Appendix B: Agency Correspondence

To: CJV
From: LINK427 Design Team
Title: Pond-2 Outlet Relocation

Date: Thursday, June 27, 2019
No. MEMO-250 R1

**Re: Pond-2 Outlet and Drainage Feature Technical Memo
Highway 427 Extension Project
GEO Morphix Project No. PN17022**

Figure 1 - Pond-2 Outlet Original and Proposed Location

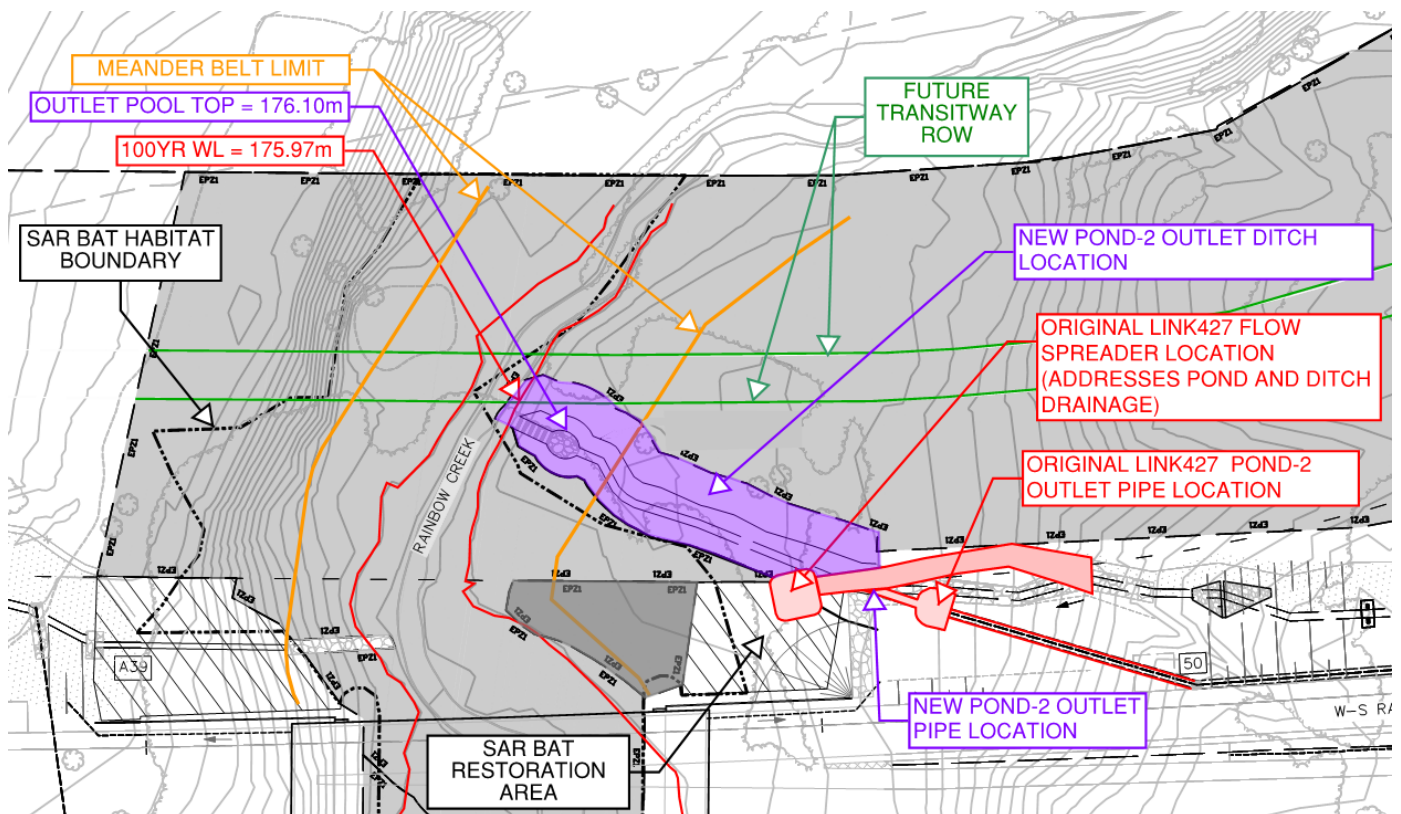
This memorandum has been prepared to identify that there has been a change to the location of the Pond-2 outlet, the reasons for the outlet relocation and the implications on potential impacts to the environment and on future infrastructure due to the new location of the outlet.

In the design presented in DCR#4 (original LINK427 design), the outlet pipe from Pond-2 discharged to a plunge pool as shown in blue in **Figure 1**. From there, runoff was conveyed by a swale to a flow spreader shown in red in **Figure 1**. From the flow spreader, runoff was to sheet flow over vegetated surfaces, ultimately discharging to the creek. Subsequently, the 3D surface modelling for the outlet area was refined and it revealed that positive drainage could not be provided with the original outlet configuration. In order to provide positive drainage, the flow spreader would have to be relocated at a lower elevation and be moved within the EPZ2 (shown in dark grey in **Figure 1**) and within Species at Risk (SAR) bat habitat (SAR bat habitat boundary depicted by dashed line in **Figure 1**), which was not a feasible option, as the flow spreader would have been a permanent disturbance in an area (EPZ2) where only temporary disturbance is allowed. After multiple design iterations and multidisciplinary review, it was concluded that the optimal location would avoid the SAR bat habitat, the Future transitway right of way and the EPZ2 area. This optimal location is highlighted in purple in **Figure 1**.

As shown in **Figure 1**, the outlet pipe from Pond-2 will still discharge near the original location. Runoff will then be conveyed via a bio-swale, which directs flows to a pool at the base of the slope for increased flow retention and infiltration. Both the bio-swale and pool are lined with a mix of soil and granular materials (e.g., river stone) and covered with a biodegradable erosion control blanket (see attached stormwater management details, DWG 2213). Additionally, a high density of live staking is proposed throughout to enhance the stability of the feature through root generation. During periods of high flow, runoff will be guided downstream of the pool through a series of wattles, which will act to further regulate flows near the creek. The wattles will consist of bundles of live woody debris bundles, which should be sourced on-site, where possible. Additionally, based on input from the fluvial geomorphologists, the placement of the drainage feature has been intentionally situated away from any immediate channel meanders. A level of lateral migration is expected over the long term beyond 100 years but it is not considered significant. Bio-swale details have been included in the attachment (Stormwater management details, DWG 2213). It is worth mentioning that the relocation of Pond-2 outlet was not caused by nor will impact Pond-2 hydrology or hydraulics. Further details relating to hydraulic of the bioswale and outlet design as well as implementation and restoration recommendations are described in the Pond-2 Outlet and Drainage Feature Technical Memo by Geo Morphix attached.
